October 16, 2017

Commissioner Tom Landwehr  
MN Department of Natural Resources  
ATTN: PolyMet NorthMet Project  
500 Lafayette Road N, Box 45  
St. Paul, MN 55155-4045

Thank you for the opportunity to submit comments for the NorthMet Draft Dam Safety Permits Nos. 2016-1380 and 2016-1383. These permits are a mere eight pages, but the length of the permits belies a basic truth about the proposed NorthMet Mining Project: by design, these dams are expected to hold back mine waste forever. To reiterate: earthen berms rising 250 feet above the surrounding area and constructed on top of 50 year old mine waste slurry are expected to contain 225 million short tons of powdered rock and water, and to do so indefinitely without unreasonably risking the public's health, safety, or welfare.

### Figure 1 - FTB Groundwater Monitoring Wells

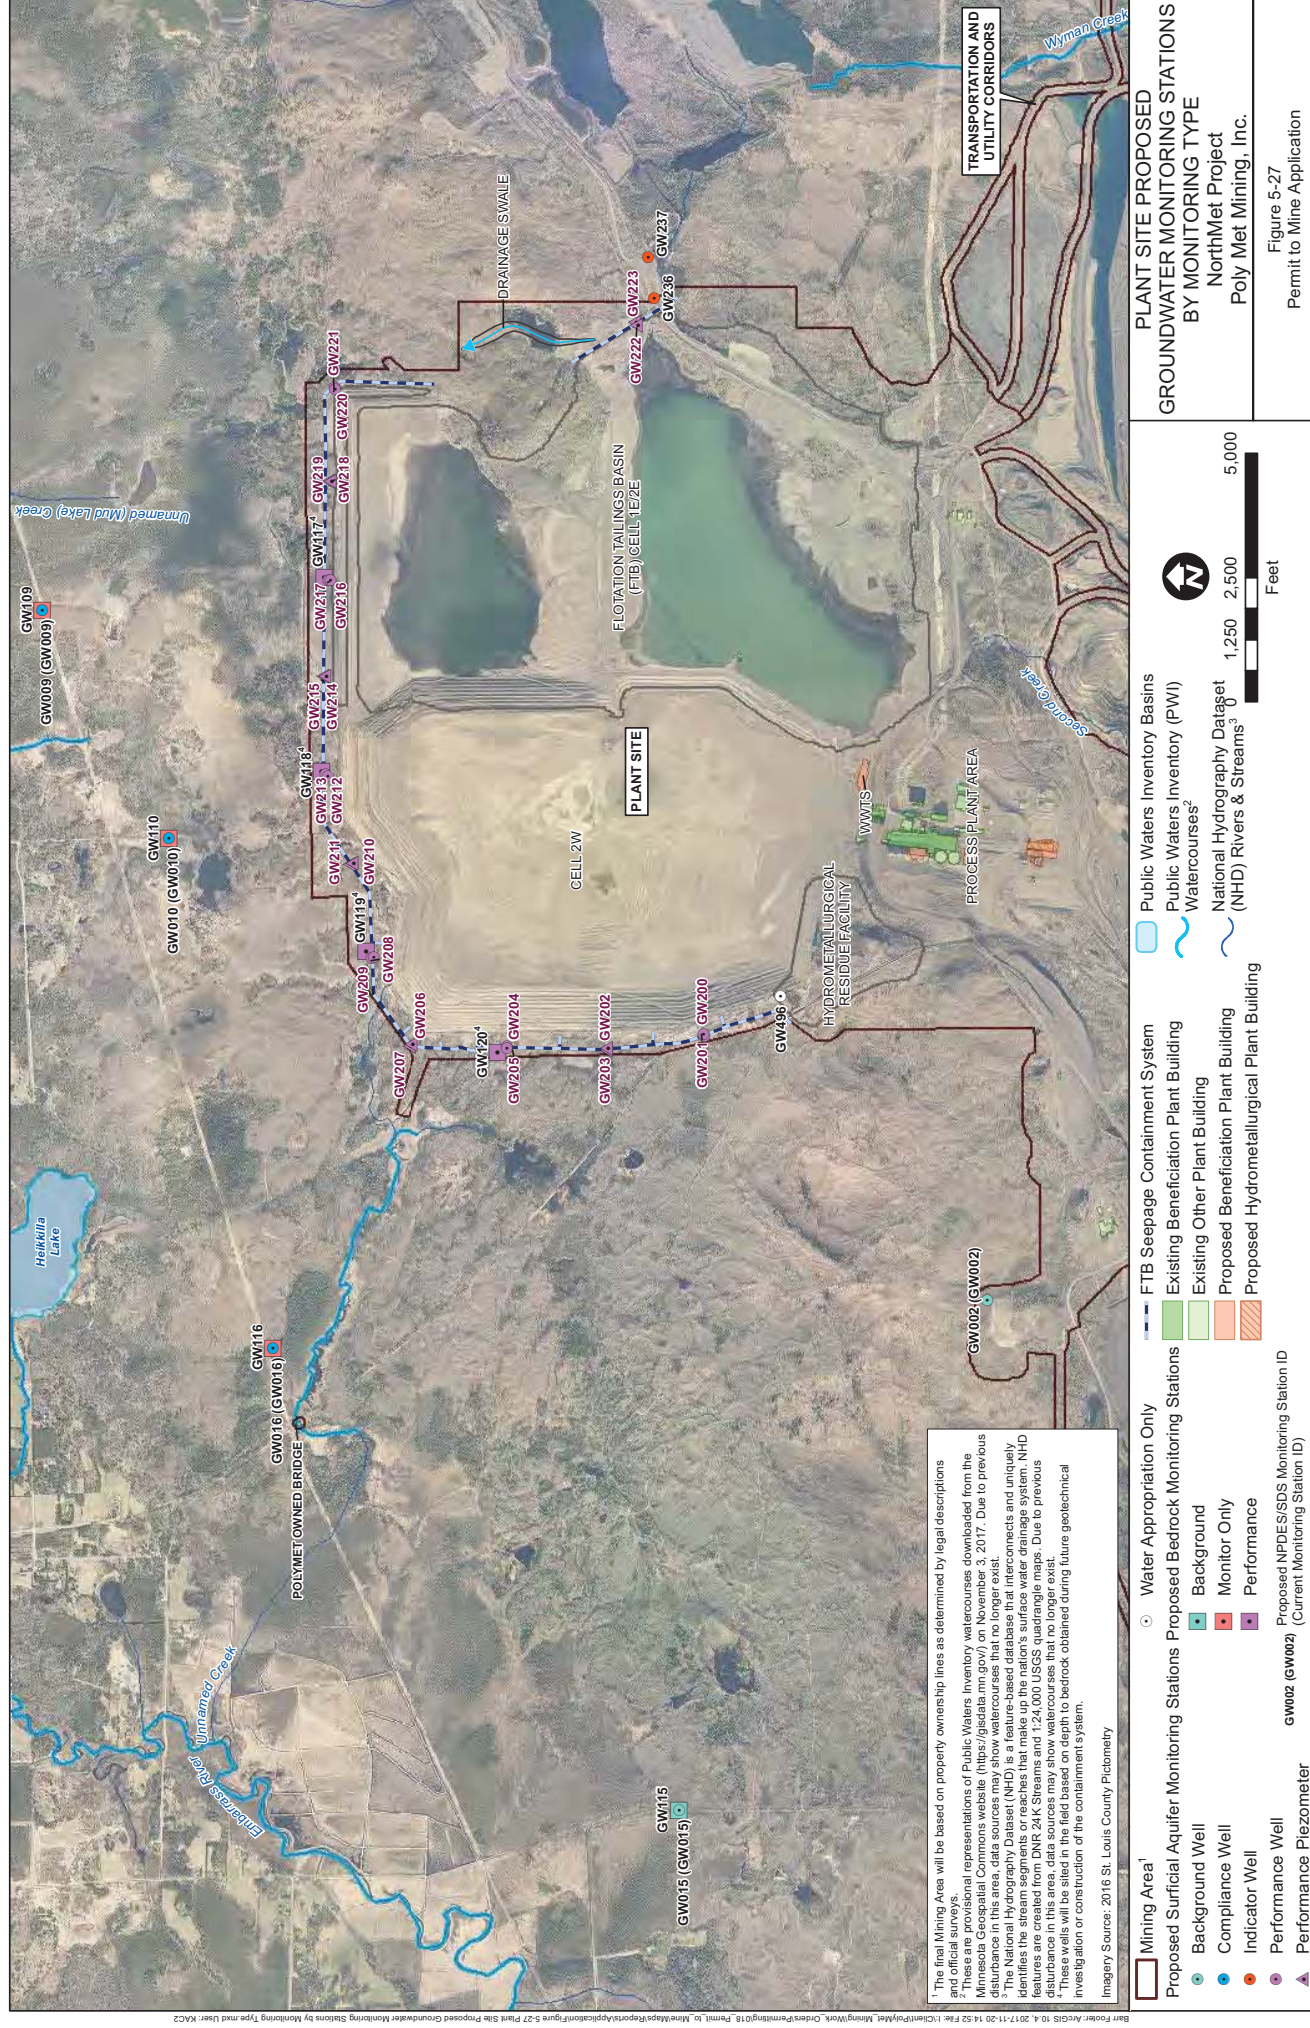
Presently the monitoring wells planned are shown in Figure 1 - FTB Groundwater Monitoring Wells. The surface groundwater flow pattern is shown in Figure 2 - FTB Groundwater Contours.

Figure 2 - FTB Groundwater Contours

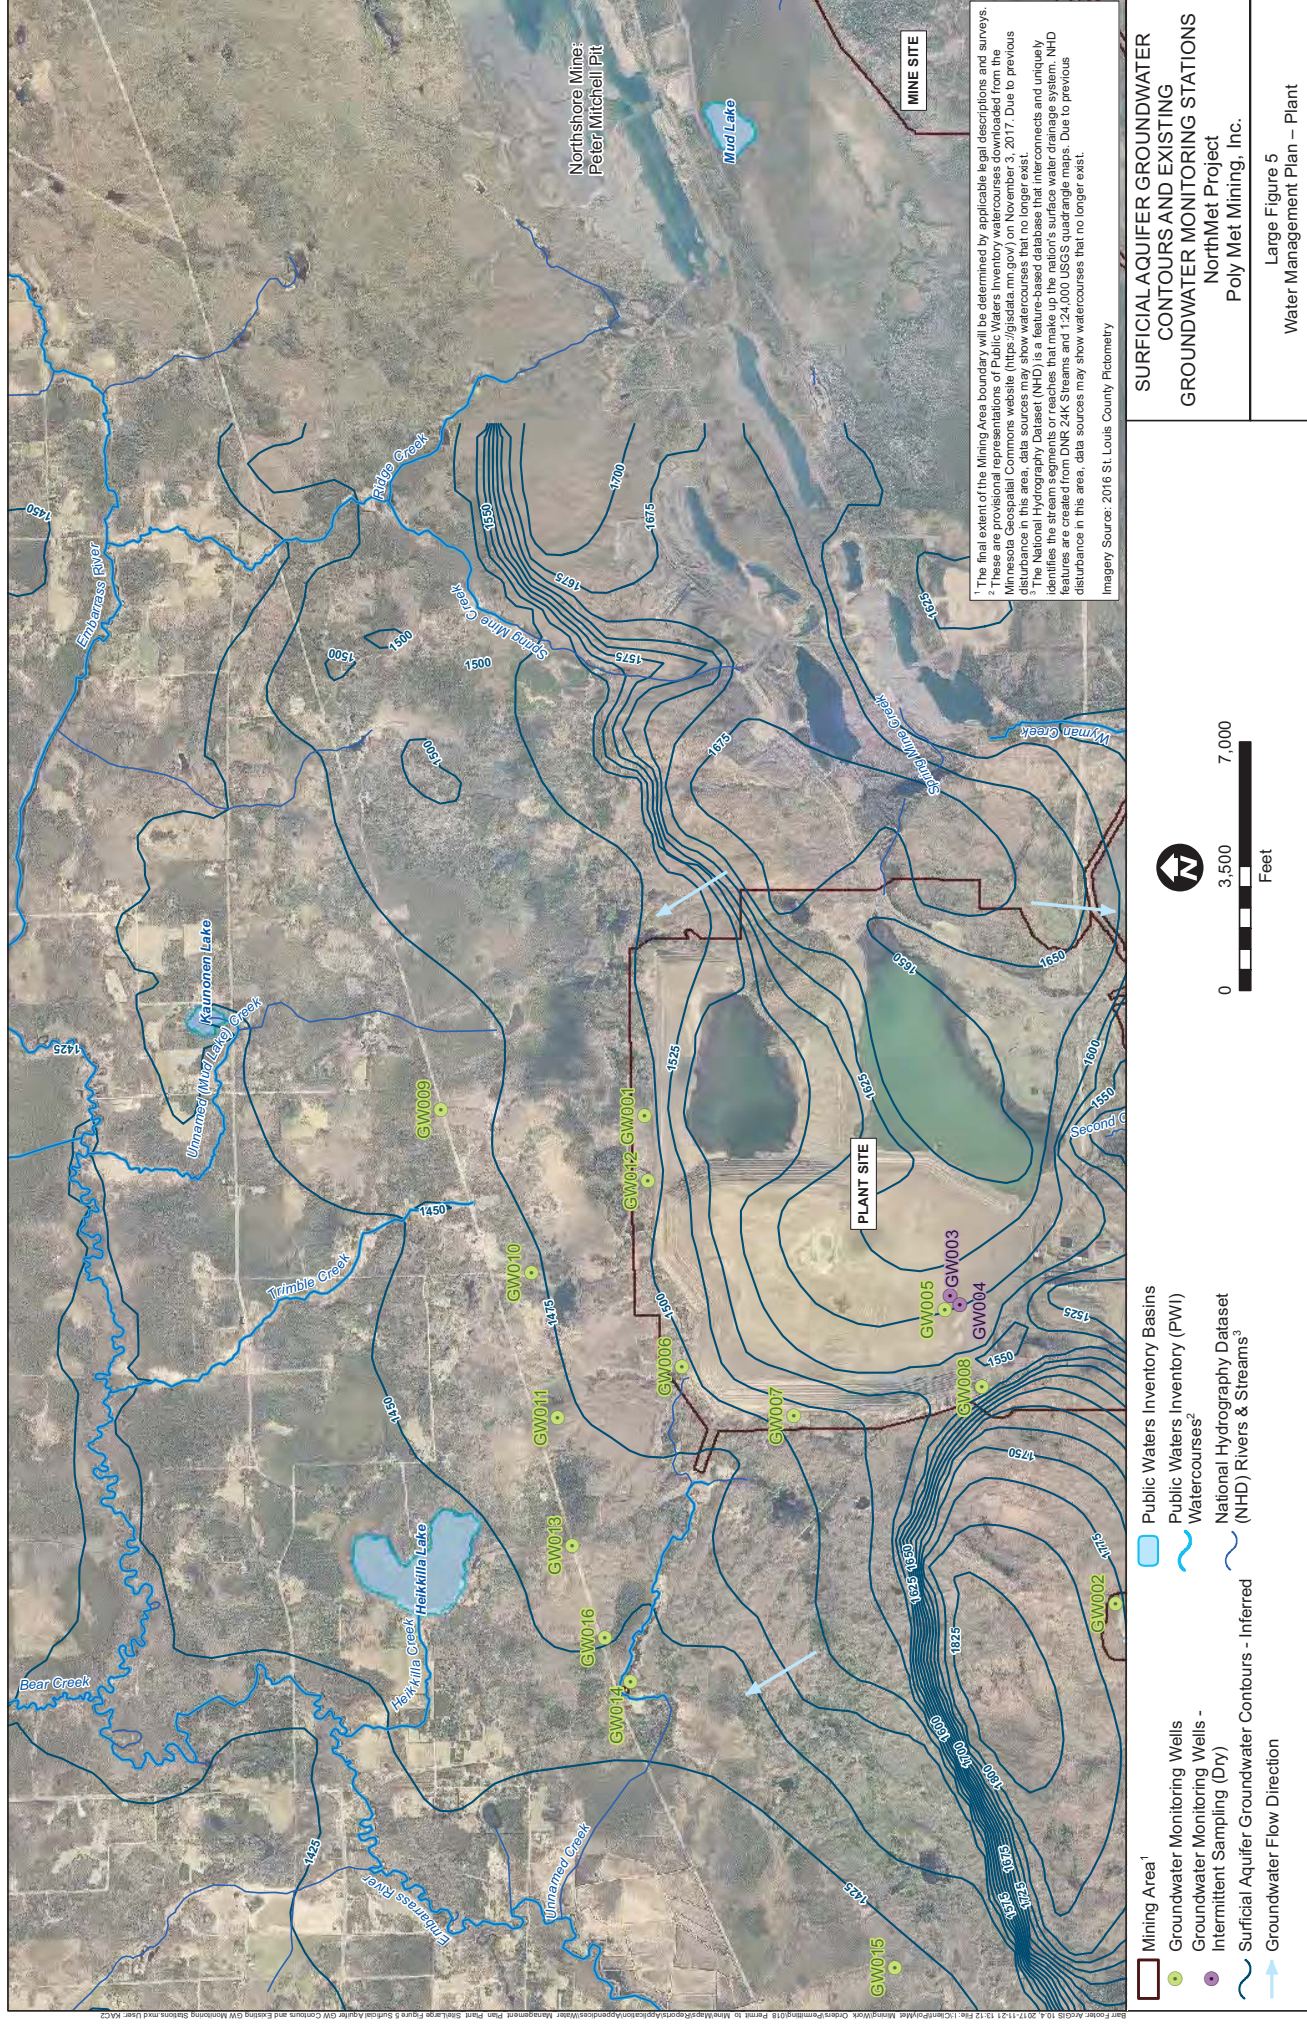
Existing well GW008 (Figure 2) might be an appropriate location for a monitoring well northeast of the Hydrometallurgical Residue Facility, but there is no appropriate existing or planned well located south/southeast of the Hydrometallurgical Residue Facility. Monitoring wells are needed for the Hydrometallurgical Residue Facility.

**Figure 12. Flotation tailings humidity cell results for pH and nickel; (a) tests with pH values <7 in pink shading, (b) enhanced nickel leaching when pH values are <7 (pink shading) and applicable groundwater and surface water quality standards.**

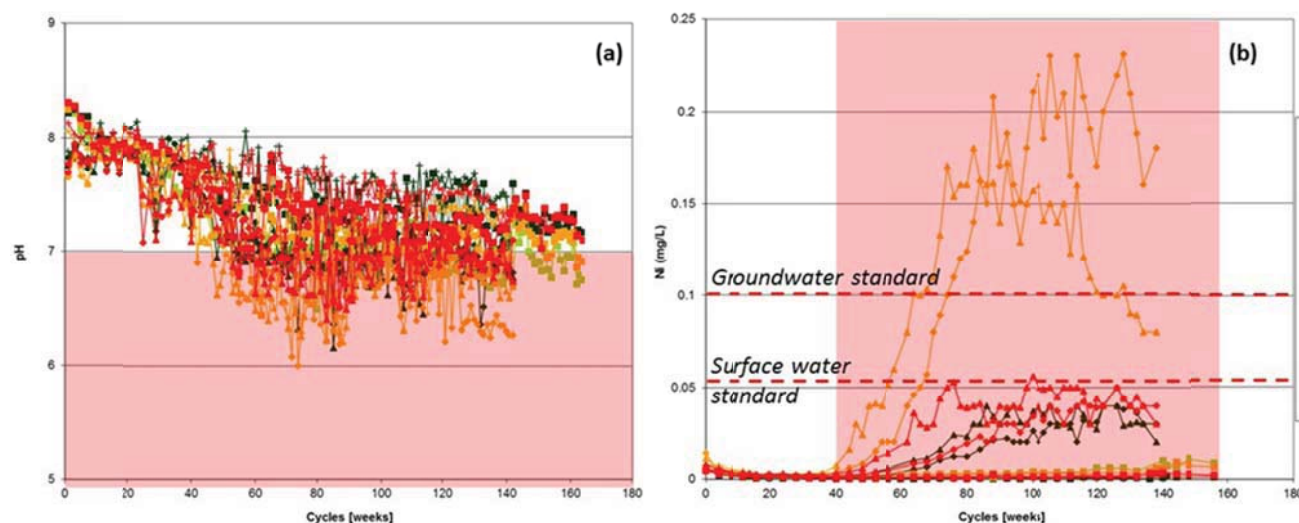
In terms of pH, a discrepancy exists between statements in reports and the leach test results. PolyMet Mining, 2017b (p. 10), which contains mine waste characterization summaries, states that the kinetic testing results for the flotation tailings show “no indication of trends below pH 7” or “with lowest pHs typically above 7.” As shown in Figure 12a, many pH values are below 7, with values as low as pH 6.

Samples with pH values below 7 also show enhanced nickel leaching (Figure 12b) with cobalt and manganese concentrations following very similar trends. SRK (2007b, p. i) notes that kinetic testing by MDNR and PolyMet “on coarse (>200 mesh fraction) tailings has shown that nickel and cobalt leaching accelerates when pH falls below 7 due to re-leaching of weathering products formed at higher pH.” These results indicate that the tailings are reactive even under non-acidic leaching conditions. According to PolyMet, 2017b (p. 10), the mineralogy of the flotation tailings is similar to that of Category 1 waste rock. If that is the case, Category 1 waste rock could also activate the release of nickel and cobalt if the pH drops below 7.

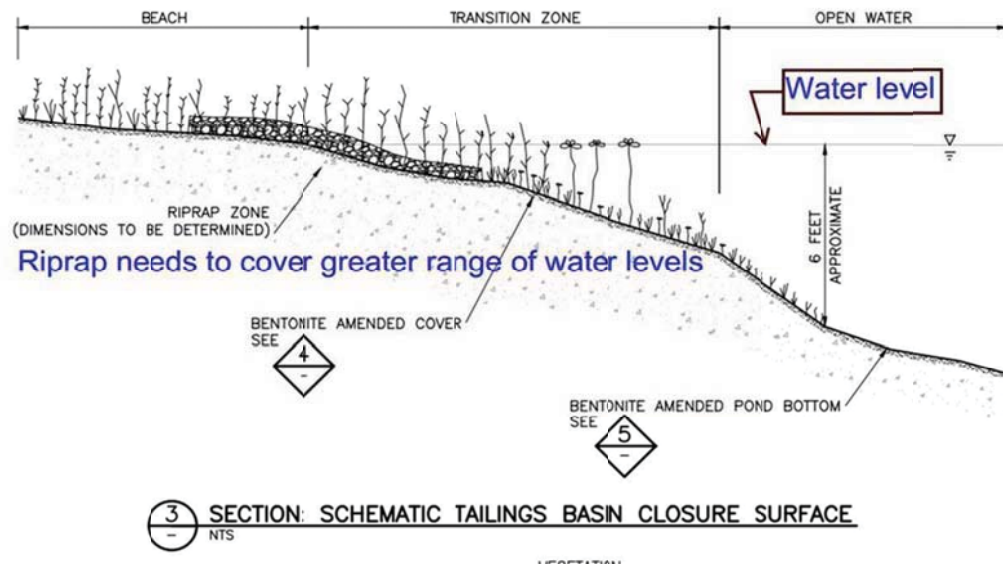
1. As shown on the drawings, (FTB-009) none of us completely understand the function of the 4-foot thick coarse LTV tailings underdrain beneath lifts 1 and 5 along the north face of the embankment. It appears that the underdrain will collect and direct surface run-off into the embankment, potentially saturating the embankment, and reducing the stability. This item requires further explanation and review. (see first image below) We don't think that the purpose of the underdrain is to collect surface water, but that's what is illustrated.

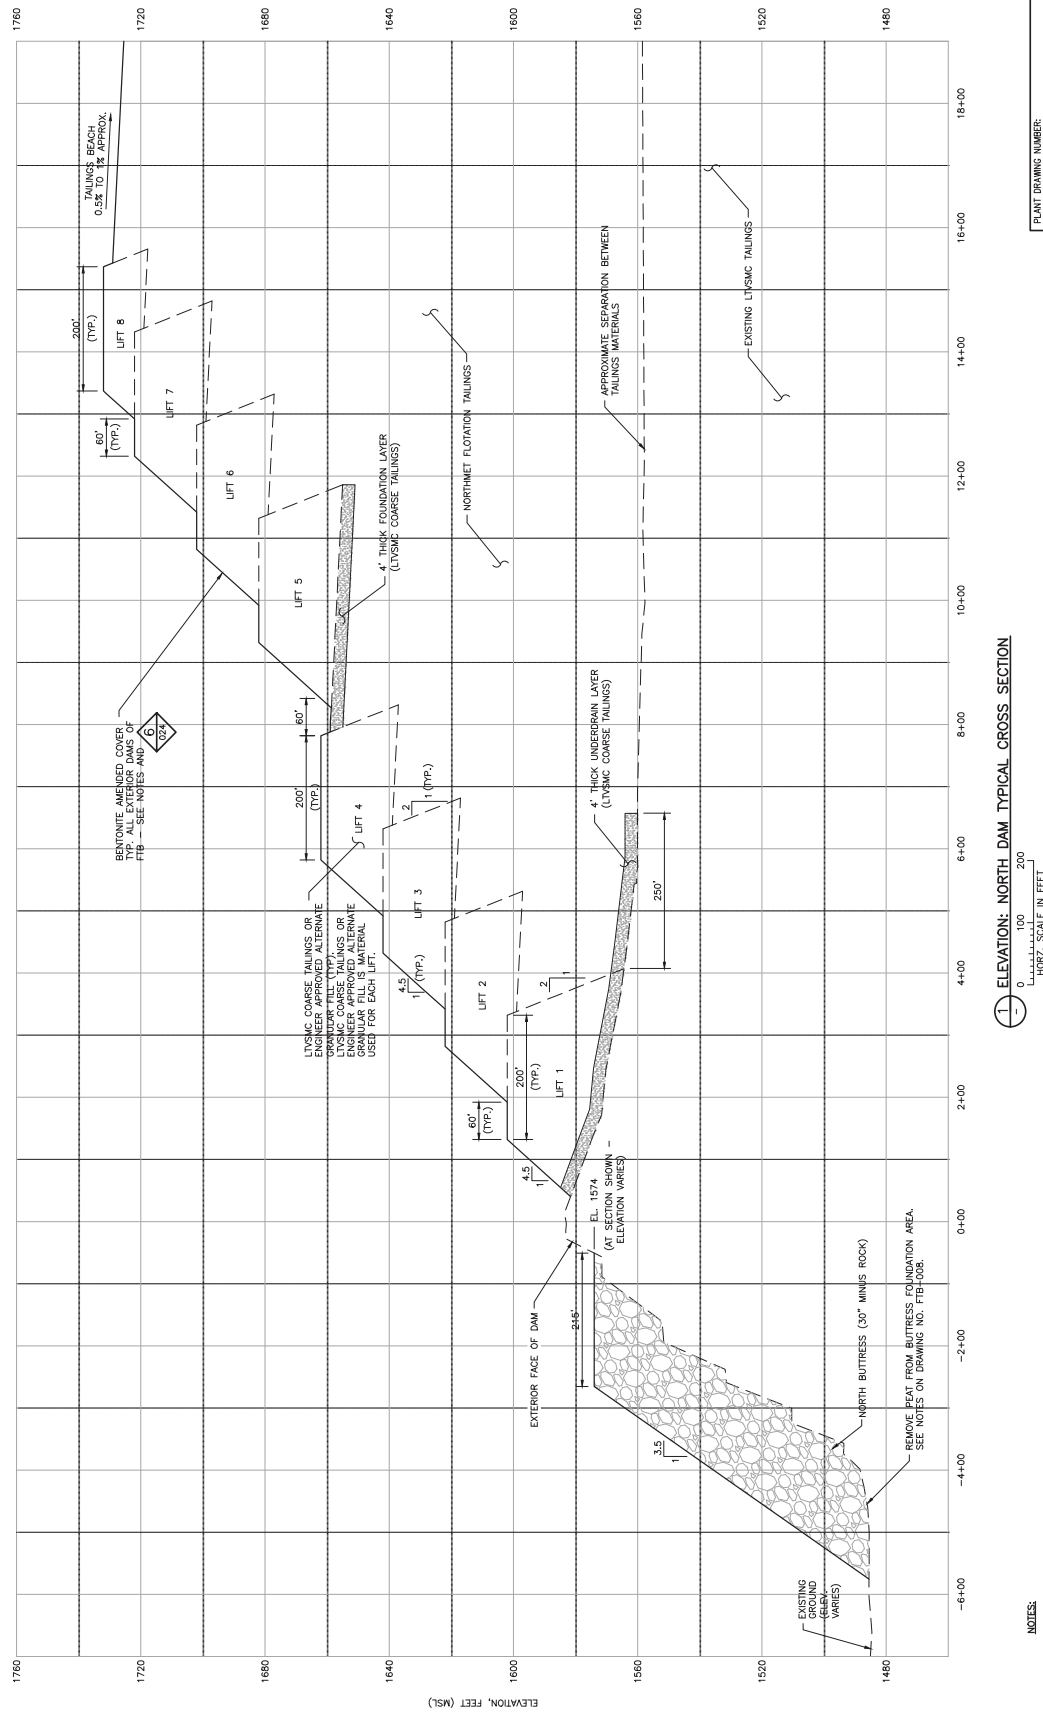
4. As illustrated in Drawing FTB-024, the portion of beach protected by riprap appears to be too narrow, but the width is subject to change. The total extent of the riprap needs to be designed as part of the closure. The size and thickness of riprap need to be justified based on wave action and ice. If the water level fluctuates, wave action could erode above or below the riprap, thus setting up a head cutting scenario from the inside towards the embankment. This could lead to piping and embankment failure. (see second image below). The 625 foot beach slopes 1%, then transitions to a 3% slope to the pond bottom. If the water level drops below the elevation predicted, then the 1% to 3% transition nick point could initiate a head cut that will run back to the embankment. This could trigger piping by allowing water a clear path into the coarse embankment fill when the water level rises. This may not be an issue if the site is perpetually managed and repaired, but will be an issue if the site is abandoned. The water level will not remain constant unless it is managed. If it is not managed, then depending on the bentonite efficacy, the pond could either periodically dry up or over fill. Climate change makes precipitation predictions 100 or 200 years from now impossible, so the design needs to assume the worst case. The range of water level possibilities needs to be addressed in the closure design. If the water level drops lower than designed due to higher infiltration rates or lower precipitation, then the geochemistry assumptions will change as the tailings dry out and oxidize.

Figure 11: Sulfate concentration at PolyMet mine site, year 11 after start of mining, layer 3.

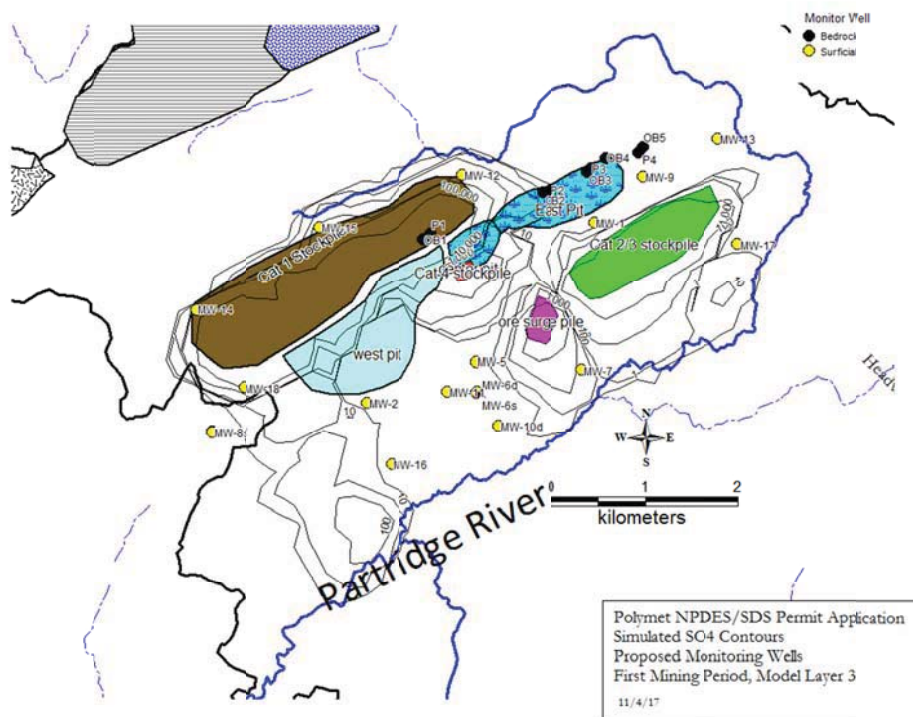
Simulated plumes down to 1 ug/l would mostly miss the proposed monitoring wells south of the mine site (Figures 11-14). The plumes miss monitoring wells MW-5, MW-6s and d, MW-10s and d, and MW-11. At 14 years, the shape of the plume in layer 4 (Figure 14), deeper bedrock, paralleled that in layer 3 (Figure 12). Simulated seepage from these facilities was distributed

Contaminant plumes emanating from various facilities reach the Partridge River within 11 years (Figure 11). This occurs because the OSP and Category 2/3 stockpile are wholly or partly south of the groundwater divide and because seepage from the Category 1 stockpile flows west of the drawdown caused by the West Pit, as noted above (Figure 9).

Figure 19: Sulfate concentration graph at well MW-7.

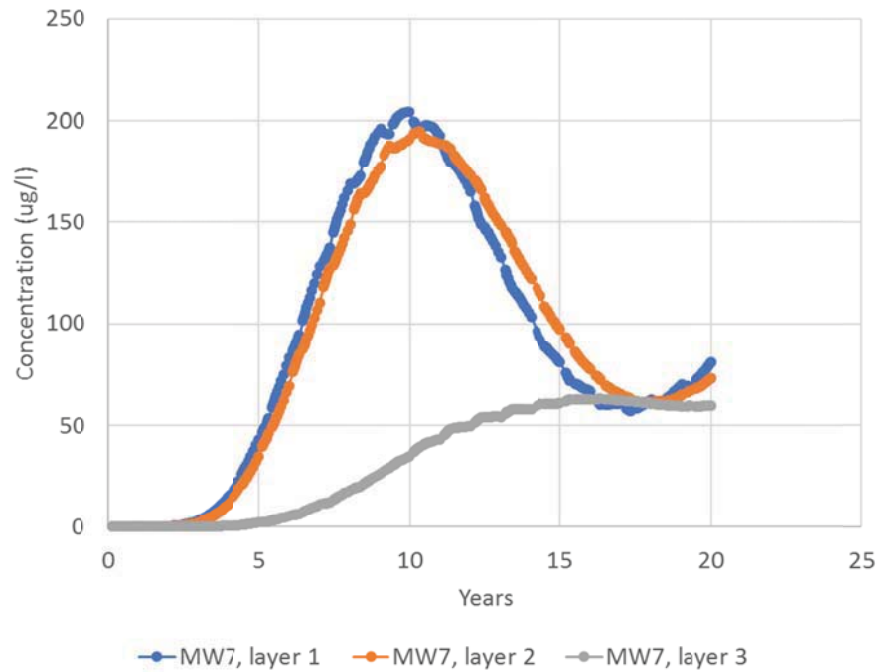
Monitor well MW-7 lies just east of the Category 2/3 stockpile (Figure 9). If transport went southeast from that stockpile, the monitoring well would detect it, but instead it peaks at or near 200 ug/l (Figure 19). The plume lies southwest of this monitor well. Monitor well MW-05-
